Access Compliance Report

Public Rights-of-Way

(Curb Ramps)

Intersection ID: 44958	Main Street: N_TRYON_ST	Cross Street: OLD_CONCORD_RD	Location: SE
ADA ID: D88D995750D0	Ramp Type: Perp	Initial Pass/Fail: Pass	Overall Compliance: No
Severity Score: 5.25			
Codes/Mitigation Info/Possible Solution		Field Measurements/Component Compliance

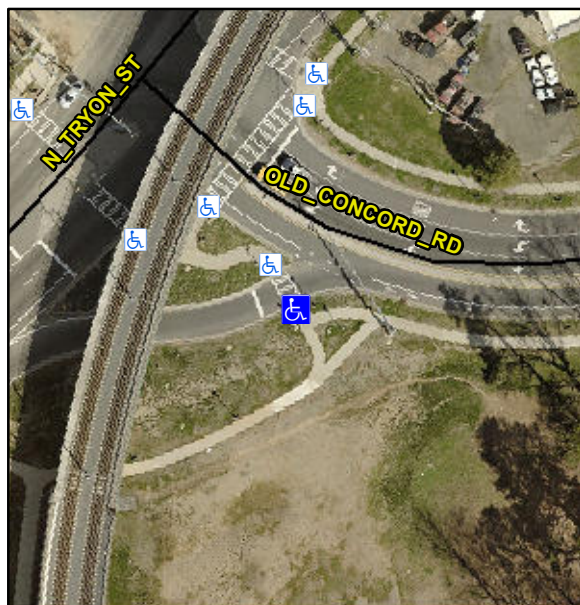
Not Found, R304.5.3, R304.5.4

Compliance	Description	Data	Compliance	Description	Data
N/A	Ramp Length (in)	96.0	Yes	Ramp Slope (%)	7.4
Yes	Ramp Width (in)	96.0	No	Ramp XSlope (%)	2.6
Yes	Flare Type LT	Curbed_NoWalkSurface	Yes	Flare Type RT	N/A
Yes	Flare Slope LT (%)	N/A	N/A	Flare Slope RT (%)	N/A
N/A	Flare Traversable LT?	No	N/A	Flare Traversable RT?	No
Yes	Landing Length (in)	73.0	Yes	DWS Provided?	Yes
Yes	Landing Width (in)	96.0	Yes	DWS Contrast?	Yes
Yes	Landing Slope (%)	0.7	Yes	DWS Length (in)	24.0
Yes	Landing X Slope (%)	0.7	Yes	DWS Full Width?	Yes
N/A	Landing Curb? (Y/N)	No	Yes	DWS Offset (in)	0.0
N/A	Shared Landing?	No			
Yes	Gutter Ponding?	No	No	Gutter Slope (%)	5.9
Yes	Gutter Lip Ht (in)	0.0	Yes	Gutter X Slope (%)	0.1
N/A	Painted X Walk1?	Yes	N/A	Painted X Walk2?	N/A
	X Walk 1 Direction	To NW		X Walk 2 Direction	N/A
N/A	X Walk 1 Width (in)	95.0	N/A	X Walk 2 Width (in)	N/A
	X Walk 1 Slope (%)	0.2		X Walk 2 Slope (%)	N/A
	X Walk 1 X Slope (%)	2.0		X Walk 2 X Slope (%)	N/A

**Remove & Replace Entire Ramp.
Remove & Replace Gutter.**
